Saad Saan Apparels Ltd.

Jamirdia, Valuka, Mymensing, Bangladesh.
(24.291828 N, 90.405102E)

28th November 2015

Observations

Sagged Horizontal Bracing Cables Sewing Shed

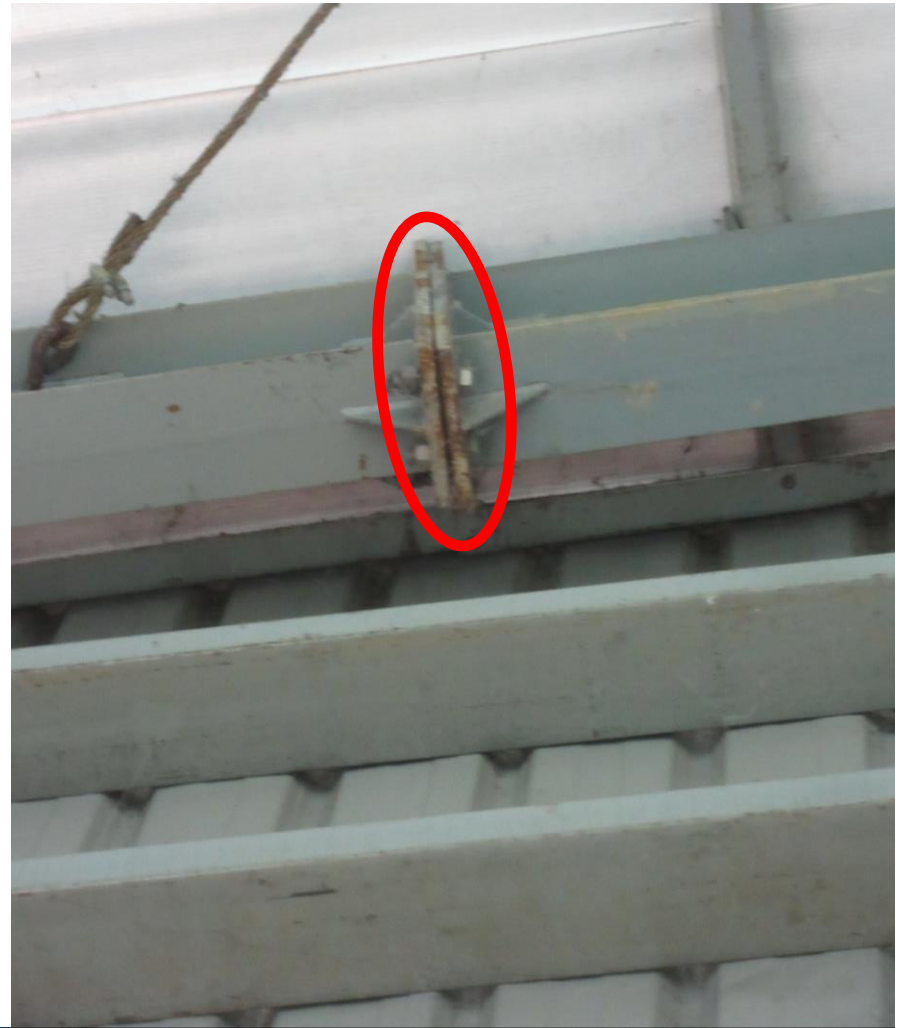
Missing Vertical Bracing in Sewing Shed

Missing vertical bracing in Sewing Shed on both ends of the shed.

Sagged Horizontal Bracing Cables

Horizontal bracing cables observed to be sagged.

Gap between End Plates At Frame Beams Sewing Shed

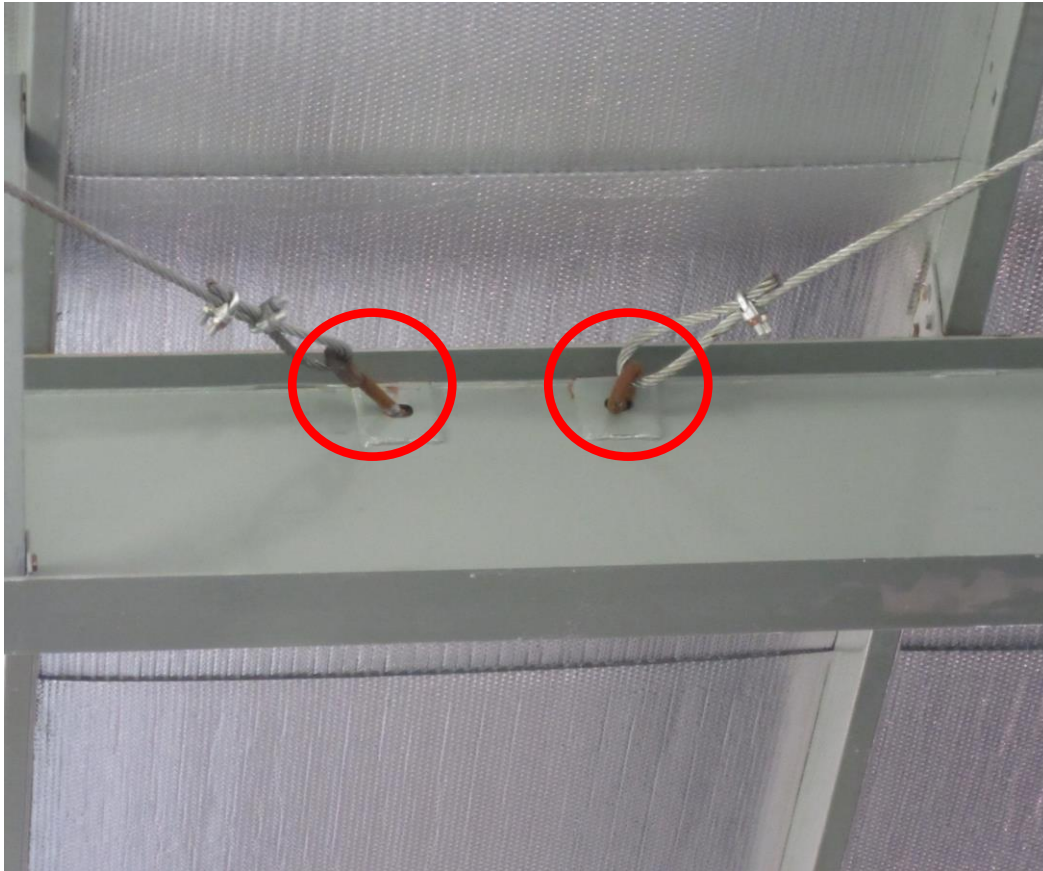
Nuts not Visible on Column-Base Plate Joints Due to Concrete Cover in Sewing Shed

Nuts could not be seen at the base plate connection.

Gaps between End Plates of Frame Beam Splice Connections
